Supporting documents to discharge Condition 4:

Condition 4 officer response below to re-submission made in Jan 23:

Land Adjacent to No 12, Rochdale Lane, Heywood

The surface water drainage scheme assessment

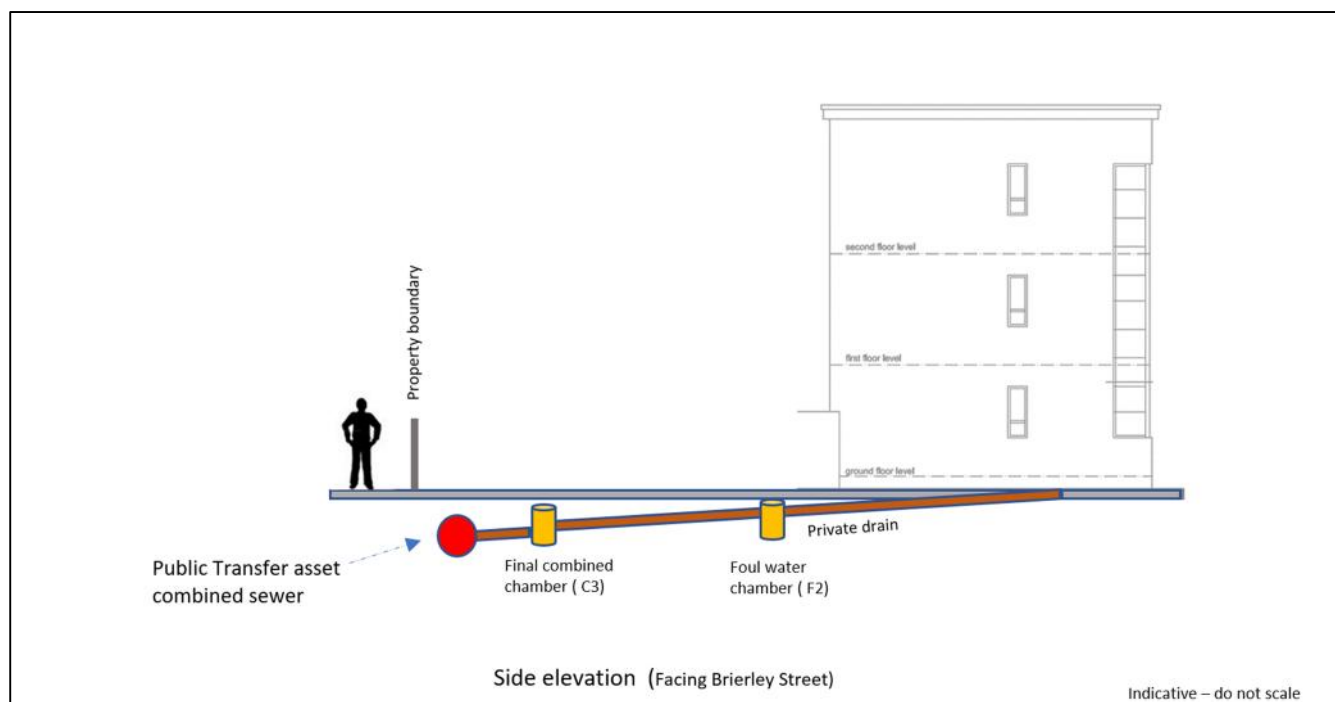
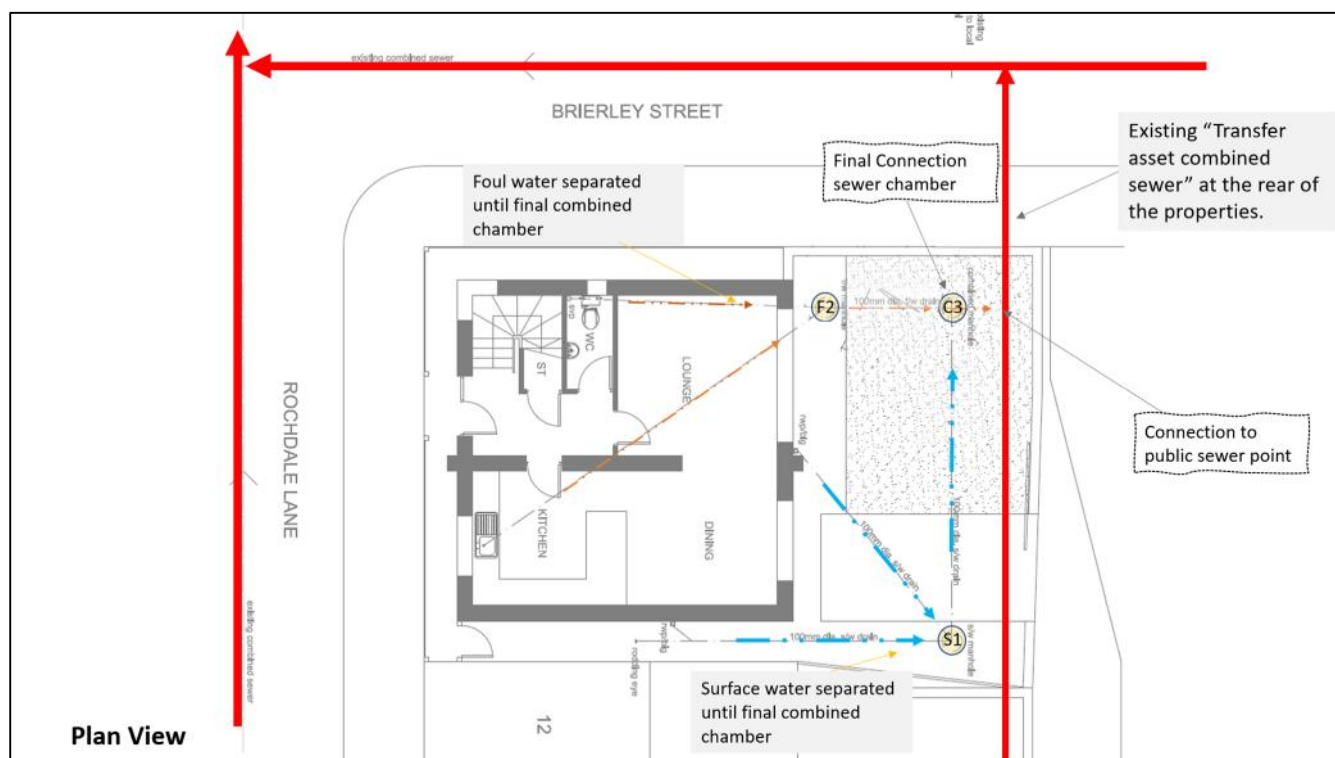
- a) Details of permeable paving, including cross-section; suppliers details can be included. Dimensions of the driveway entrance shall be included, to demonstrate whether a vehicle can reverse out of the driveway.
- b) Accurate plan details of how the dwellings connections to public sewer will be made. In accordance with Building Regulations H (Drainage) foul and surface water shall be separated until the final connection chamber."

The proposed location for the connection is at the rear of the proposed property to the existing Transfer Asset sewer. We have liaised with United Utilities PLC of the connection point as shown in the plan view below, and UUPLC is satisfied with the drainage plan and proposed connection.

Also, in accordance with Building Regulations H (Drainage) foul and surface water is kept separated until the final connection chamber C3 as shown below.
